Immediate Action Required User Safety Notice SN070523

3M™ Scott™ Air-Pak™ Wireframe, Air-Pak™ 75, Air-Pak™ NxG7 (Upgraded), Air-Pak™ X3 SCBA and Spare Assemblies

Figure 1

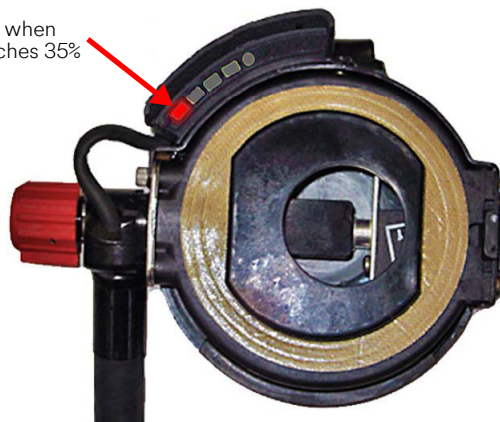
3M™ Scott™ Fire & Safety has received a small number of reports of Air-Pak 75, Air-Pak NxG7 (upgraded), Air-Pak X3 SCBA and spare consoles that were shipped with incorrect programming of the Heads-Up Display (HUD) secondary EoSTI. In the reported cases, although the Vibralert primary EoSTI will alarm at 35% of cylinder pressure in accordance with regulatory requirements, the HUD console lights will only indicate low air (red flashing light as illustrated in **Figure 1**) when the cylinder pressure reaches 25%. While both signals are measuring accurately, the HUD lights for these SCBA editions should be illuminating at 35%.

Red light should flash when
cylinder pressure reaches 35%

If you identify one or more consoles within the date range, please remove the SCBA from service and contact your 3M Scott Authorized Service Center (ASC) to complete the repairs required.
